Larkin Subdivision - Malfroy Road

Completion of Engineering Works, Stage II

LARKIN SUBDIVISION
MALFROY RD.
STAGE II.

MEMORANDUM : CHIEF INSPECTOR

Scale Penetrometer testing on
fill sections :- location &
mean bearing.

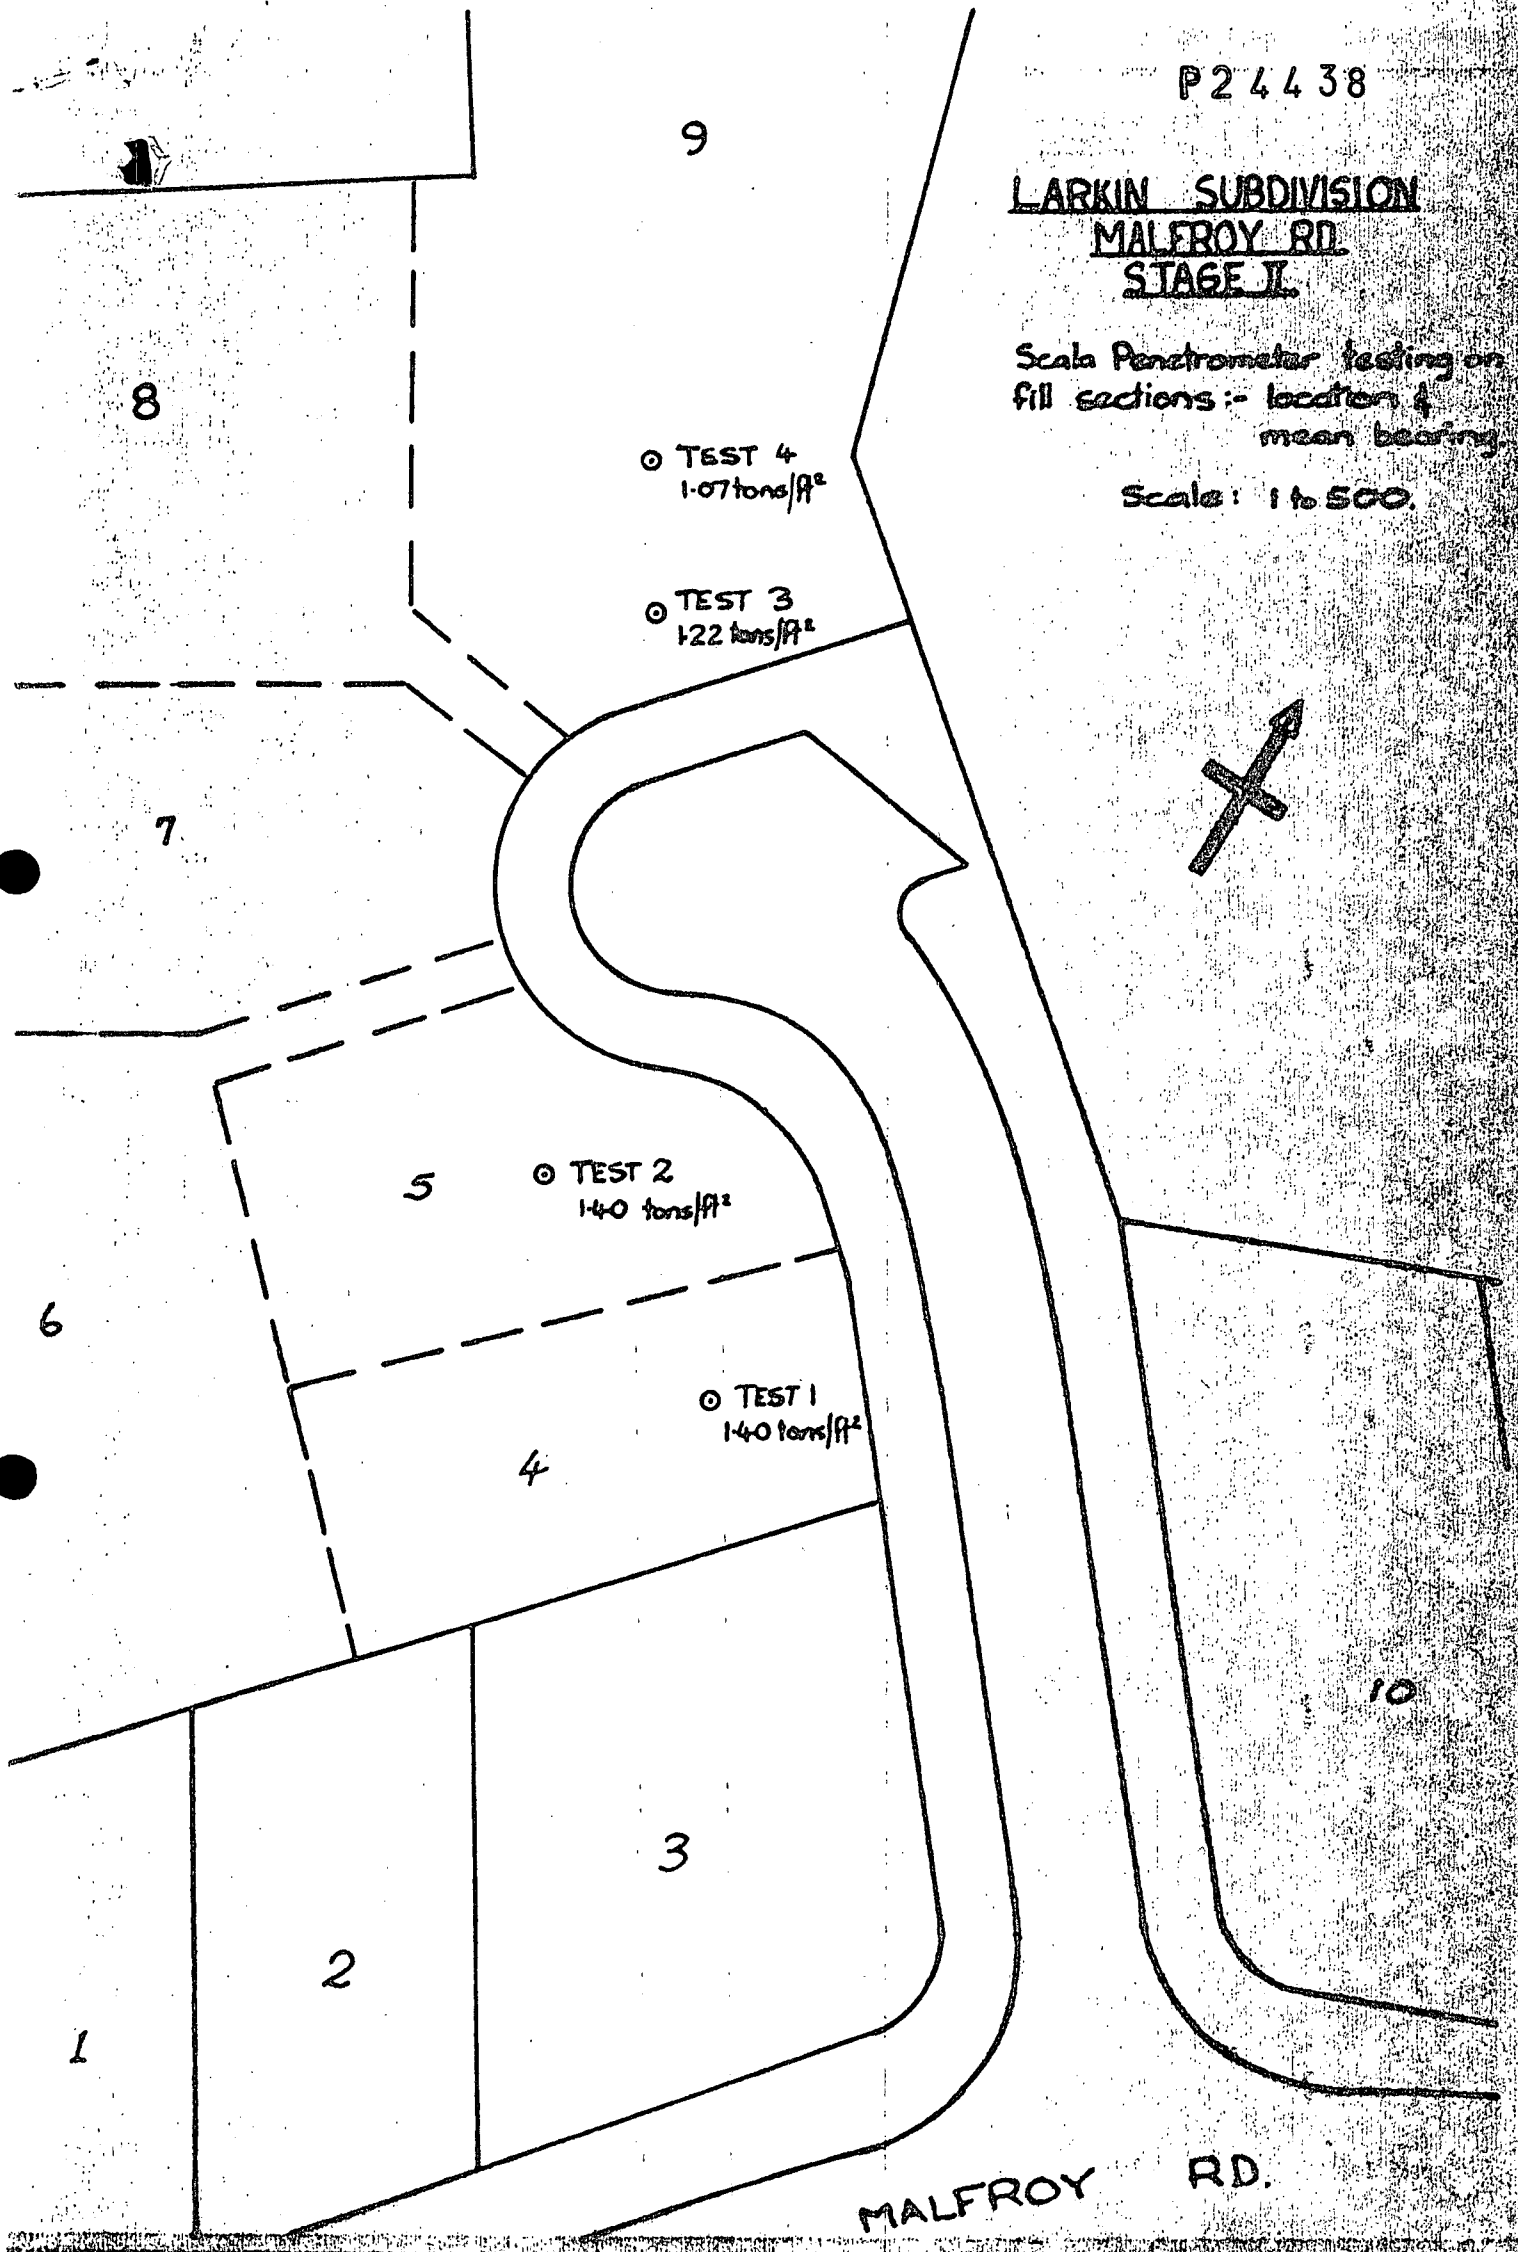
Please note the recommendations regarding foundation investigations before building permits are issued. Such investigations must be required, as a good deal of uncontrolled filling has gone into this area.

*Note max. bearing pressure to
foundations on lots 4-5 & 9
1 ton ft².
16-5-79*

Mr. <u>THOMPSON</u>
REFERRED FOR YOUR:
Information <u>HAVE PROP FILED</u>
Reply <u>FOR LOTS 4-5 & 9 MADE</u>
Inspection <u>UP, WITH A COPY OF</u>
Report <u>THIS ON EACH ONE</u>
Comment
<u>17-5-79</u> <u>Chief Insp.</u>
